**City of Ketchum  
Planning & Building**

**STAFF REPORT  
KETCHUM CITY COUNCIL  
MEETING OF MARCH 15, 2021**

**PROJECT:** Warm Springs Ranch

**APPLICATION TYPES:** Development and Rezoning Agreement, Large Block Preliminary Plat, and Block 1 Subdivision Preliminary Plat

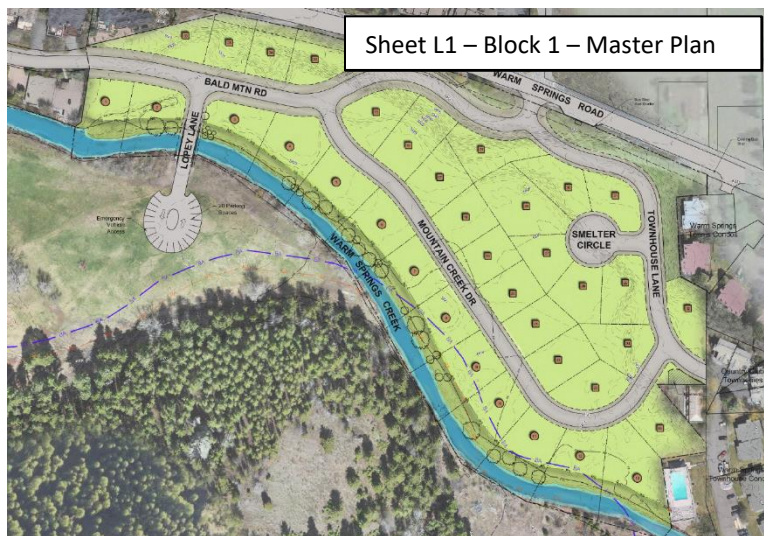
The applicant has requested waiver from certain street design and grading standards due to the site's topographical challenges. The applicant's waiver request and associated analysis is included as Attachment E to the Staff Report. Staff supports approving the applicant's waiver request because the project will improve the development's site circulation design, enhance safety, and expand pedestrian access.

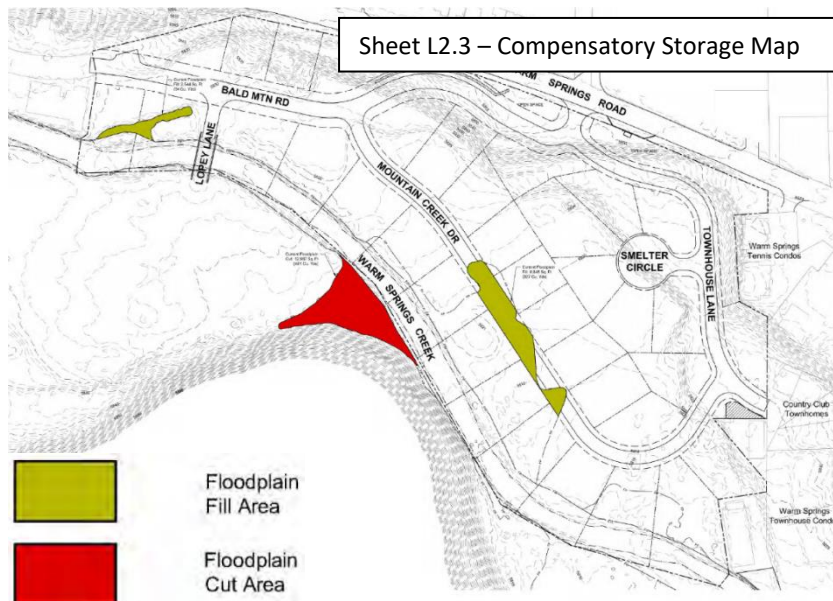
The fill proposed in the floodplain is proposed for two reasons: creation of suitable building sites and grading related to the construction of Mountain Creek Drive. There are two (2) lots, Lots 1 and 2, which are located on the upstream (western) side of the existing bridge that would be unbuildable without the addition of fill. These two lots are traversed by a manmade, historic irrigation ditch that is no longer in use. Fill in the amount of 94 cubic yards is needed to level out these lots. For visualization purposes, a standard home oven (3' x 3' x 3') is approximately 1 cubic yard in volume.

To fill in changes in topography and grade the area of Mountain Creek Drive that traverses the floodplain 327 cubic yards of fill are required.

Because the placement of fill in the floodplain can potentially displace floodwaters elsewhere, Ketchum Municipal Code has two special requirements for fill in the floodplain:

The applicant has proposed to locate compensatory storage on the south side of Warm Springs Creek in an area that is not proposed for residential development, as indicated in the diagram above.

The applicant is pursuing its required permit for fill from FEMA and has not yet received FEMA's approval. As such, staff recommends continuing the hearing on the floodplain application to a date certain.

The applicant can proceed with their Preliminary Plat approval. However, prior to adding fill within the floodplain, the city must issue its floodplain development permit. Similarly, because this scope of work includes restoration of the riparian zone, this permit must also be issued prior to work in the riparian zone.
